Access Compliance Report

Public Rights-of-Way

Intersection ID: 21011	Main Street: TOWER_POINT_DR	Cross Street: SARDIS_RD_NORTH	Location: NE
ADA ID: 8224D9DD6F12	Ramp Type: Perp	Initial Pass/Fail: Fail	Overall Compliance: No
Severity Score: 31.25			
Codes/Mitigation Info/Possible Solution		Field Measurements/Component Compliance

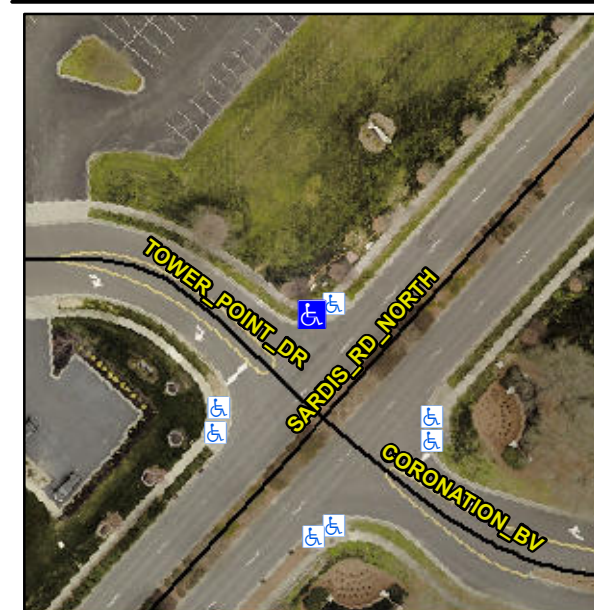
R304.5.1, R304.2.2, R304.5.3

Compliance	Description	Data	Compliance	Description	Data
N/A	Ramp Length (in)	62.0	No	Ramp Slope (%)	10.4
No	Ramp Width (in)	32.0	No	Ramp XSlope (%)	4.6
N/A	Flare Type LT	N/A	N/A	Flare Type RT	N/A
N/A	Flare Slope LT (%)	N/A	N/A	Flare Slope RT (%)	N/A
N/A	Flare Traversable LT?	N/A	N/A	Flare Traversable RT?	N/A
N/A	Landing Length (in)	N/A	N/A	DWS Provided?	N/A
N/A	Landing Width (in)	N/A	N/A	DWS Contrast?	N/A
N/A	Landing Slope (%)	N/A	N/A	DWS Length (in)	N/A
N/A	Landing X Slope (%)	N/A	N/A	DWS Full Width?	N/A
N/A	Landing Curb? (Y/N)	N/A	N/A	DWS Offset (in)	N/A
N/A	Shared Landing?	N/A			
N/A	Gutter Ponding?	N/A	N/A	Gutter Slope (%)	N/A
N/A	Gutter Lip Ht (in)	1.0	N/A	Gutter X Slope (%)	N/A
N/A	Painted X Walk1?	No	N/A	Painted X Walk2?	N/A
	X Walk 1 Direction	To SW		X Walk 2 Direction	N/A
N/A	X Walk 1 Width (in)	N/A	N/A	X Walk 2 Width (in)	N/A
	X Walk 1 Slope (%)	7.0		X Walk 2 Slope (%)	N/A
	X Walk 1 X Slope (%)	1.4		X Walk 2 X Slope (%)	N/A

Remove & Replace Entire Ramp.
